**XR6, XR10, XR20, and XR40 Update**

**November 19, 1998**

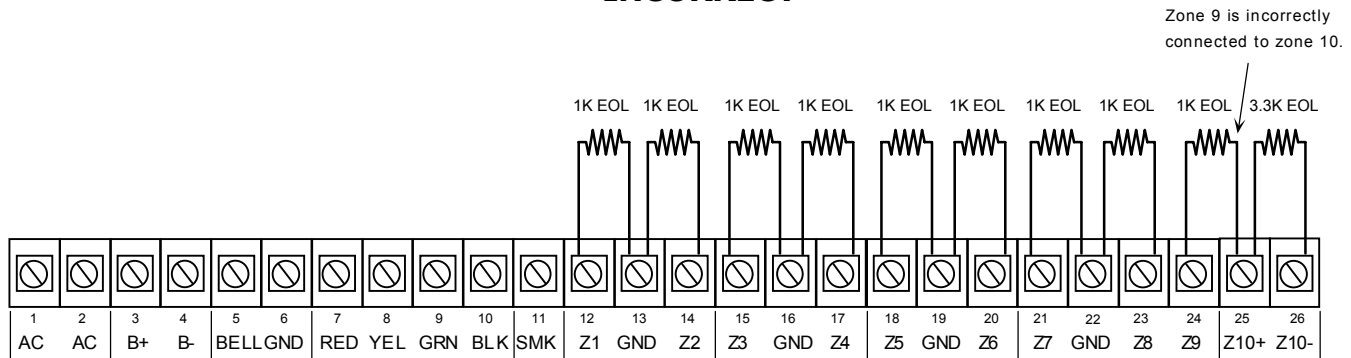
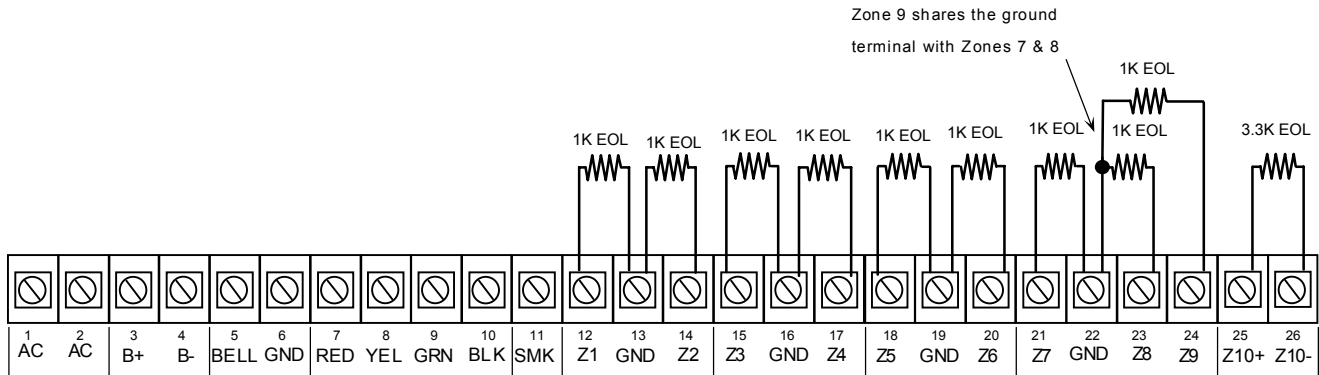
The end-of-line resistor for zone 9 must not be accidentally connected to the positive terminal of zone 10 as shown below.

**INCORRECT**

When zone 9 is incorrectly connected to zone 10, a false alarm may occur on zone 2 of the panel when the panel picks up the telephone line to communicate to the receiver.

**CORRECT**
